THOROLD TUNNEL

INSPECTION OF ROCK SLOT  
SOUTH OF WEST SERVICE BUILDING

EFFECT ON TUNNEL STRUCTURE  
OF CONSTRUCTING AN EXTENSION TO THE  
UPPER EAST APPROACH WALL, LOCK 7  
WELLAND CANAL

Re: Agreement No. 4242-9082-124  
Report on SLSA Proposed Works  
Adjacent to Thorold Tunnel

ACRS	MINISTRY OF TRANSPORTATION & COMMUNICATIONS	
	THOROLD TUNNEL - ROCK SLOT INSPECTION	
DETAILS OF SLOT FILL AND MANHOLES		
DATE	SEPT. 24, 1982	SCALE AS NOTED
DEPARTMENT	HEM	
PROJECT	THB	
ACRES		
DRAWING No.	PLATE 1	REV.
SHEET	OF

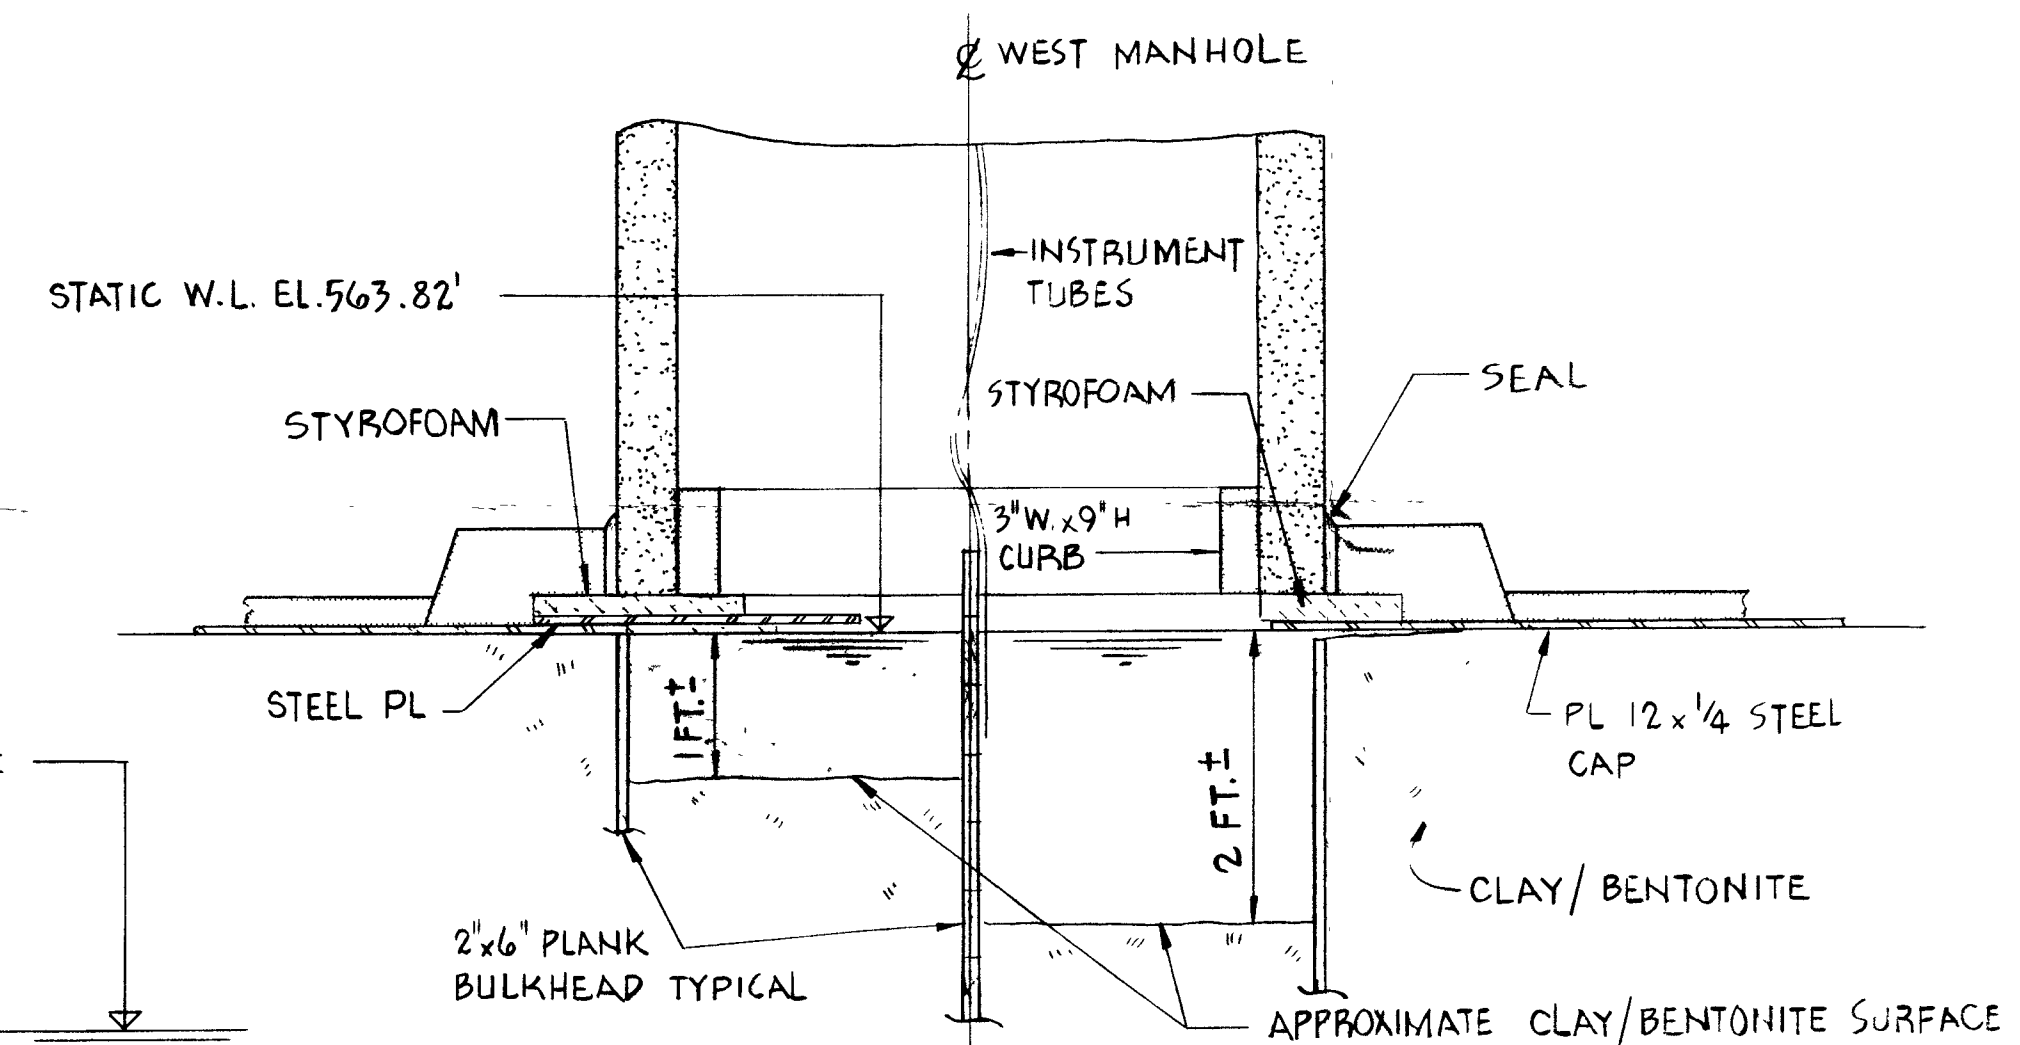
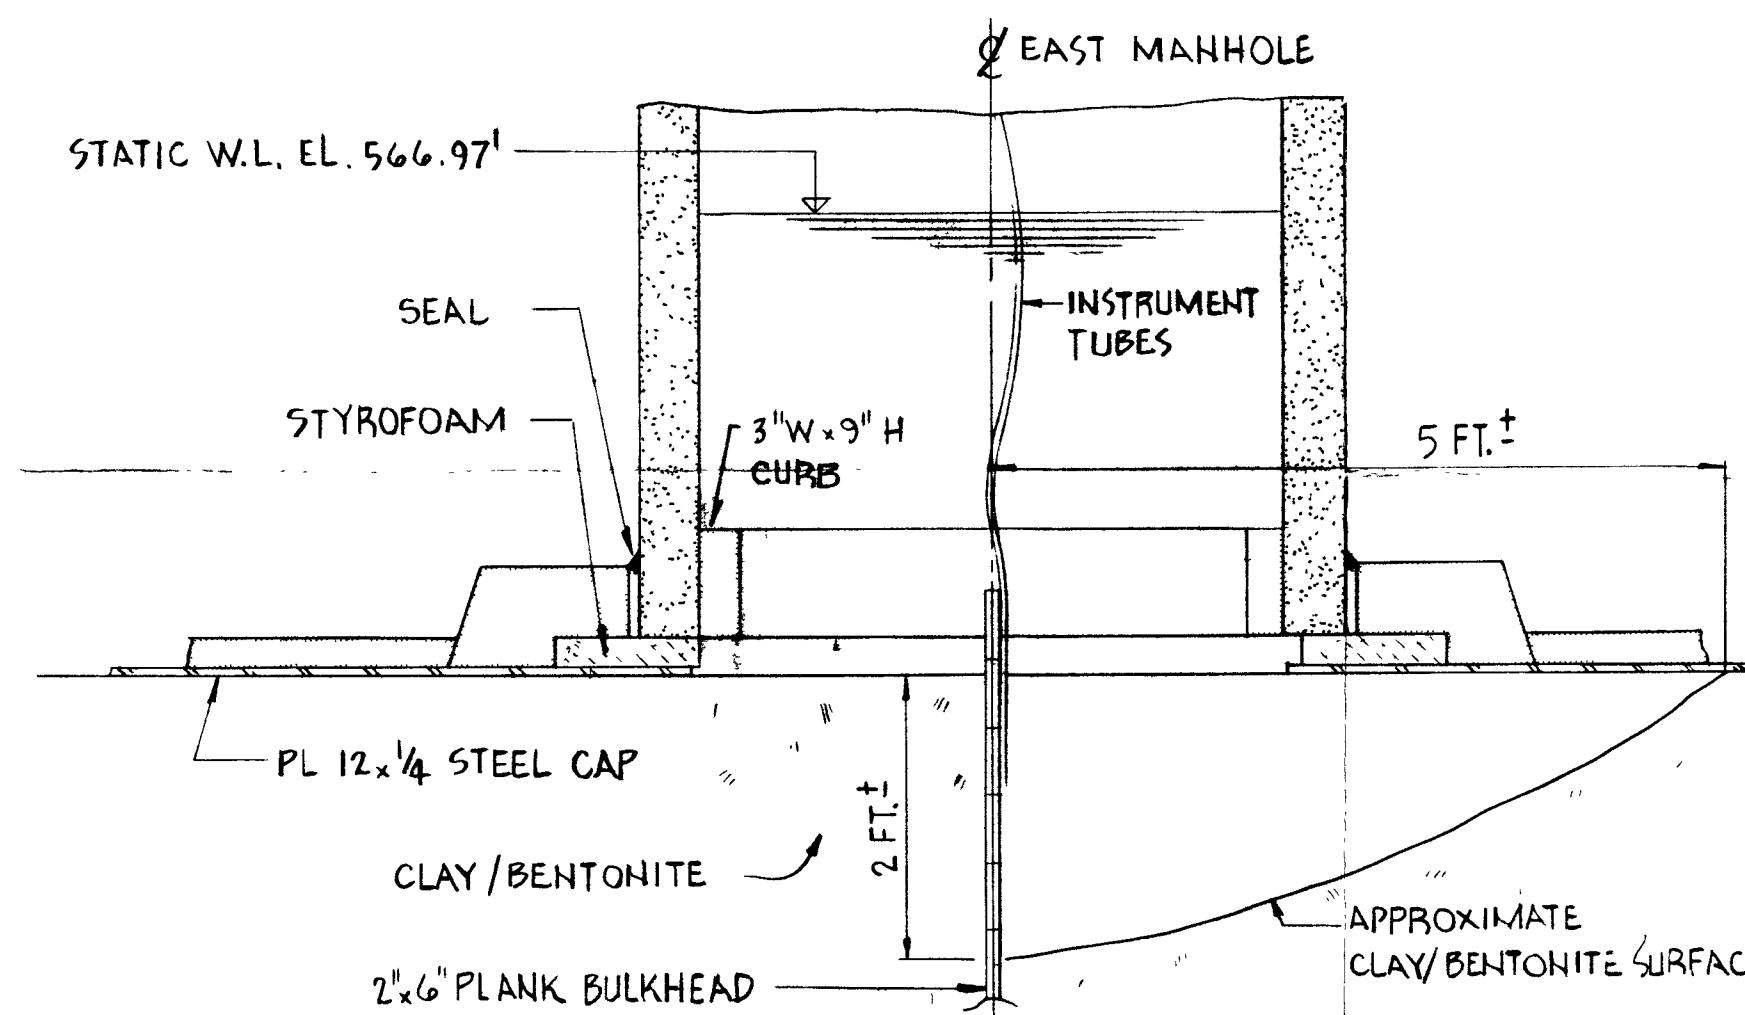
The probing within the slot was carried out using a metal fish wire which was pushed along the slot until an obstruction was encountered. Details of what was found in each manhole area are shown on Plate 1, Detail 1 representing the west manhole and Detail 2 the east manhole.

fastened, and two others under the manhole walls. The west bulkhead prevented insertion of the fish line, however it was possible to insert the fish over the bulkhead on the east side and extend it for 13.6 ft. Clay/bentonite adhering to the fish indicated that the slot was full on the east side. Within the manhole area, the slot fill was about 1 ft below the bedrock surface in the western half and about 2 ft down in the eastern half.

In the eastern manhole, only one wooden bulkhead was found near the manhole centre and it also had instrumentation tubes attached to it. The slot is full of clay/bentonite on the west side of the bulkhead, while a triangular-shaped void about 2 ft deep and 5 ft long exists on the east side (see Detail 2, Plate 1).

- (b) The lowering of the surface of the slot fill material appears to have occurred only locally at the two manholes as shown on Plate 1.
- (c) No water flow appears to be taking place along the slot indicating that the seepage control barriers across the slot and the slot fill material are performing effectively.

Since the portion of the slot without fill material is relatively small and no flow appears to be occurring along the slot, it is not considered necessary to proceed with filling the voids at this time. It is recommended that the slot be inspected in the future, say 5 years from now, to assess whether any changes have occurred.
